Certified Action of the City of Raleigh Planning Commission

Case File / Name: IR-2-12 / Red Hawk Contracting Lots 105 & 106

Recombination Layout

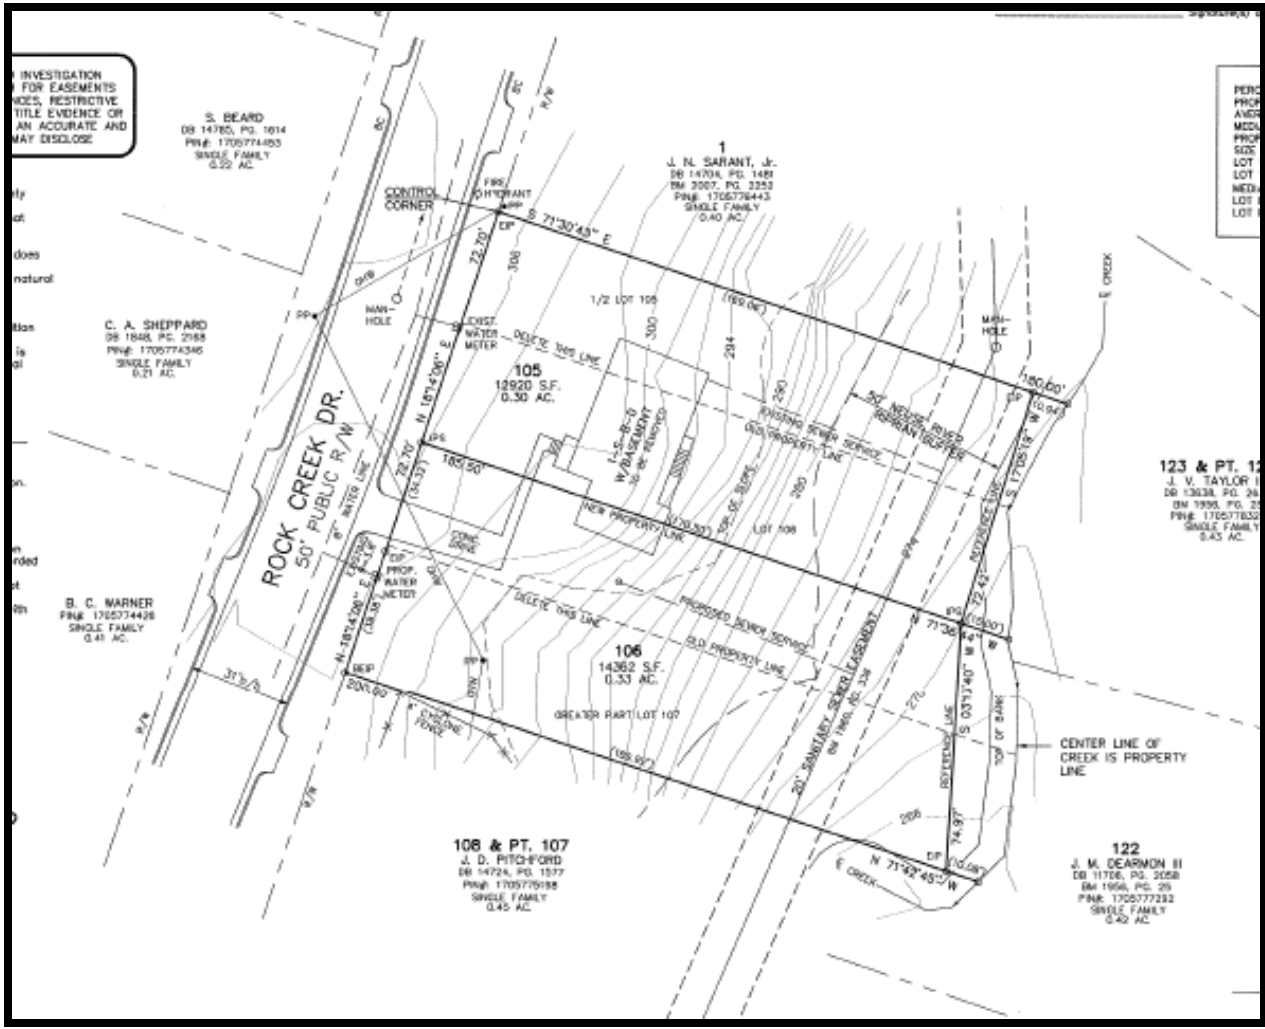
LOT LAYOUT: The minimum lot size in this zoning district is 10,890 square feet. The minimum lot depth in this zoning district is 100. Lots in this development conform to these minimum standards.

Staff finds that the proposed recombination meets infill standards 1-3 found below.

1. The lot lines are angled from the street in a similar manner as typical surrounding lots.
2. Lots consist of 4 lines as is typical of several of the surrounding lots.
3. The building envelopes for the proposed new lot(s) are placed in such a way that they are not one behind the other when viewed from the public street. Lots proposed may be adequately served by City services.

Applicant response: Lot lines for all lots are either perpendicular to the street or at a very narrow angle. Lots in the periphery are angled perpendicular to the street.

Applicant response: Both lots have 4 angles.

Applicant response: All lots are configured to be side by side and facing the street

- (1) That the Planning Commission finds that this infill project meets the lot layout standards of Section 10-3032(d);

- (2) That demolition permits be issued by the Development Services Department and permit numbers be shown on all maps for recording;
- (3) That a note stating which address and lot number is responsible for the new utility connection and fees must be shown on the map for recording; and

- (4) That a copy of the recorded map must be provided when applying for a new water tap.
-
